# Service Bulletin

**SUBJECT:** Service Update for Inventory and Customer Vehicles  
Power Steering Hose Leak  
Expires with Base Warranty

**MODELS:** 2015 Chevrolet Silverado 2500/3500 HD  
2015 GMC Sierra 2500/3500 HD  
Serviced Before September 9, 2014 (Pursuant to Recall Bulletin 14356)

3975435

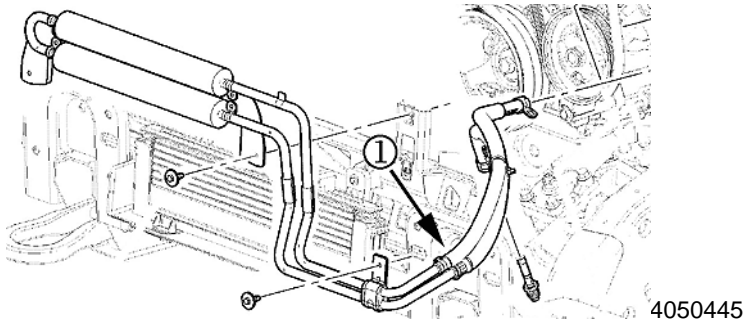
(A) Crimped ferrule with swedge marks. This is a secure connection on the pipe ferrule. (B) Uncrimped ferrule without swedge marks. This is NOT a secure connection on the pipe ferrule.

1. Open the hood and locate the section of the power steering cooler lines where the rubber hoses join the metal pipes (1).
2. Verify there is a metal collar (ferrule) on the both rubber hoses where they join the metal pipes.

3. Verify that both ferrules are crimped and display the swedge mark. Pull on the crimped end of the hose to determine if hose crimp is loose (not secure) on the pipe ferrule.

- If the power steering hose crimps are secure and show evidence of swedge marks AND the power steering hose clamps are engaged at both the power steering pump and gear locations, no further action is required. Refer to *Power Steering Fluid Leaks* in SI to diagnose any fluid leaks.

- If the power steering hose is missing a ferrule, the crimps are NOT secure or DO NOT show evidence of swedge marks, **replace the power steering fluid cooler**. Refer to *Power Steering Fluid Cooler Replacement (Heavy Duty)* in SI.
